State of Oregon
Department of
Environmental
Quality

Willamette Basin TMDL Response to Comments

WILLAMETTE BASIN TMDL

RESPONSE TO PUBLIC COMMENTS

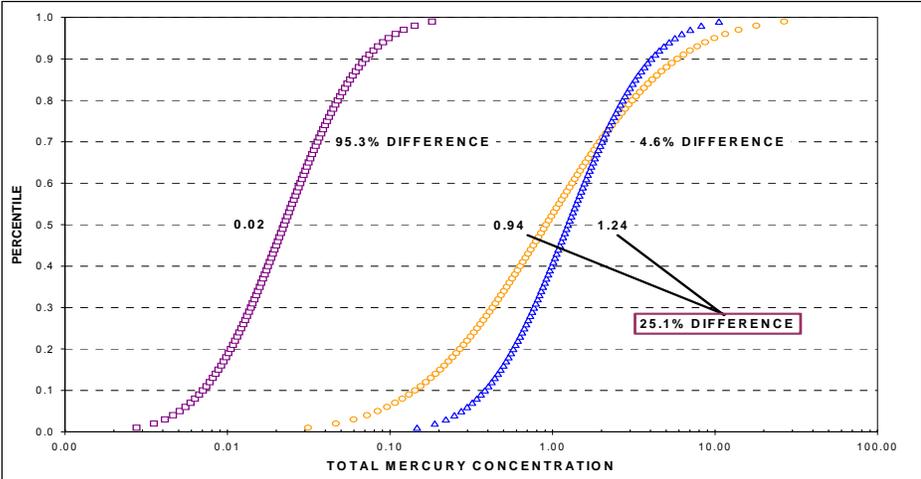
<p data-bbox="448 527 1421 772">Examination of DEQ’s limited water quality sampling to date suggests that the upper watershed reservoirs are generating methyl mercury in the summer that is flushed out of the reservoirs in the fall and winter. Mid-valley stations have relatively constant concentrations in methyl mercury, and lower-valley stations have methyl mercury production high in the summer only. These patterns suggest specific, substantial controlling mechanisms on instream methyl mercury concentrations that have not been illuminated in DEQ’s discussion that focused on the mass balance of total mercury. (c)</p> <ul data-bbox="472 804 1421 951" style="list-style-type: none"> • DEQ’s future work should be focused on better understanding the methylation processes and the spatial and temporal distributions of these processes. This information should be used to focus future TMDL efforts and guidance regarding selection of implementation strategies (55 (+35, 40, 46, 56, 63, 68, by reference)). (a) 	Increased dissolved organic carbon (DOC)	Enhanced in sediment, soil Decreased in water column	Increased nutrient concentrations	Enhanced	Increased selenium, molybdenum concentrations	Decreased	Increased temperature	Enhanced
Increased dissolved organic carbon (DOC)	Enhanced in sediment, soil Decreased in water column								
Increased nutrient concentrations	Enhanced								
Increased selenium, molybdenum concentrations	Decreased								
Increased temperature	Enhanced								
<p data-bbox="289 957 418 989">Response</p>	<p data-bbox="448 957 1421 1108">(a) ODEQ agrees with the need to gather additional region-specific data to increase our understanding of factors that affect methylation and de-methylation processes in this system. ODEQ looks forward to working with stakeholders during Phase II to obtain the resources and the funding that will be required to undertake this work in a timely and efficient manner.</p> <p data-bbox="448 1140 1421 1203">(b) ODEQ agrees with this comment and is considering adding collection of these water quality parameters to its on-going monitoring program.</p> <p data-bbox="448 1234 1421 1444">(c) ODEQ does not fully agree with this comment. Methylmercury concentrations throughout the mainstem exist within a fairly narrow range, making it difficult to clearly discern segments on the basis of such concentrations. In addition, there is no evidence to suggest that there are significant discharges of methylmercury from the reservoirs and, if there were, it is not evident that methylmercury from such a source is sufficiently persistent to be transported significant distances downriver.</p>								
<p data-bbox="215 1482 350 1503">Comment 31.</p> <p data-bbox="224 1566 407 1661"><i>Factors influencing methylmercury production: spatial considerations</i></p>	<ul data-bbox="472 1482 1421 1812" style="list-style-type: none"> • In order to more fully understand methylation processes, a reach by reach evaluation is needed. At a minimum, the Coast Fork should be evaluated separately (55 (+35, 40, 46, 56, 63, 68, by reference)). (a) • Additional co-located fish and water sampling is needed in the mainstem and the tributaries where higher methylmercury production may occur. Temporal and seasonal patterns in results from the above sampling should be evaluated. Redox, pH, sulfate, sulfide and dissolved organic carbon should be added to analytes and these results should be used in interpretation. Targeted sampling should occur in locations and at times when methylation might be high (55 (+35, 40, 46, 56, 63, 68, by reference)). (b) 								
<p data-bbox="289 1818 418 1850">Response</p>	<p data-bbox="448 1818 1421 1873">(a) ODEQ believes that it, and other investigators, have collected sufficient data to adequately characterize the Cottage Grove / Coast Fork system, and to evaluate it</p>

<p><i>separately from the mainstem. Whereas we can agree that it would be useful to divide the river itself into individual segments for more detailed analysis, ODEQ simply does not have data at this point to support an analysis at any greater level of spatial detail other than potentially separating out the Coast Fork. This is certainly something ODEQ could consider doing during Phase II of this study.</i></p> <p><i>(b) ODEQ agrees with the need to gather additional region-specific data to increase our understanding of factors that affect methylation and de-methylation processes in this system. ODEQ looks forward to working with stakeholders during Phase II of this study to obtain the resources and the funding that will be required to undertake this work in a timely and efficient manner.</i></p>
<p>Comment 32.</p> <p><i>Factors influencing mercury fate and transport</i></p>	<p>Mercury is a complicated element which behaves in very different ways depending on the form that it is in, the climatic environment, the host geology and mineralogy, vegetation, surface water composition, reducing or redox conditions (Eh), acidity (pH), etc. Because of these differing behaviors exhibited by mercury in response to physical conditions, it is not possible to make blanket predictions as to whether Hg will enter the environment and, if it does, whether it will be found in a form that will bio-accumulate.</p> <p>For an understanding of mercury transport and fate, solubility data on elemental mercury and mercury compounds, especially in water, are necessary. One of the potentially most serious environmental issues related to mercury is the chemical dissolution and the movement of elemental mercury, mercury ions, and mercury compounds in surface waters and ground water. Compared to some compounds, elemental mercury tends to be relatively insoluble in water. In addition, dissolved mercury tends to be rapidly absorbed by inorganic and organic materials in soils, sediments, and water making it less available to the environment. These factors can explain why sediments and soils with high levels of elemental mercury can have very low levels of dissolved mercury in associated surface or ground waters. Although elemental mercury is not as soluble as other forms in water, it can be converted to organic and inorganic forms under certain near surface conditions. Once in a soluble form, it may then convert to methylmercury and become readily available to the aquatic biota, or under certain aquatic conditions, it may de-methylate and once again become unavailable. Thus without a detailed understanding of current conditions, it is not possible to predict the path mercury or mercury compounds may take in the environment. Because of this unpredictability, it is essential that any limits that are established be based on an understanding of local conditions as well as potential sources and possible changes to the local environment (69).</p>

<p>Response</p>	<p><i>ODEQ agrees with many aspects of the comments listed above and the considerations listed above support and validate the incremental approach ODEQ has taken. ODEQ agrees that understanding the behavior of mercury is challenging, particularly with respect to its speciation. ODEQ does not, however, agree that "...it is not possible to make blanket predictions as to whether Hg will enter the environment..." since it clearly does, from both natural and anthropogenic sources.</i></p> <p><i>ODEQ agrees with the need to gather additional region-specific data to increase our understanding of factors that affect the movement and speciation of mercury within this system. ODEQ looks forward to working with stakeholders during Phase II of this study to obtain the resources and the funding that will be required to undertake this work in a timely and efficient manner.</i></p>
<p>Development of Guidance Values and Reduction Targets for Total Mercury</p>
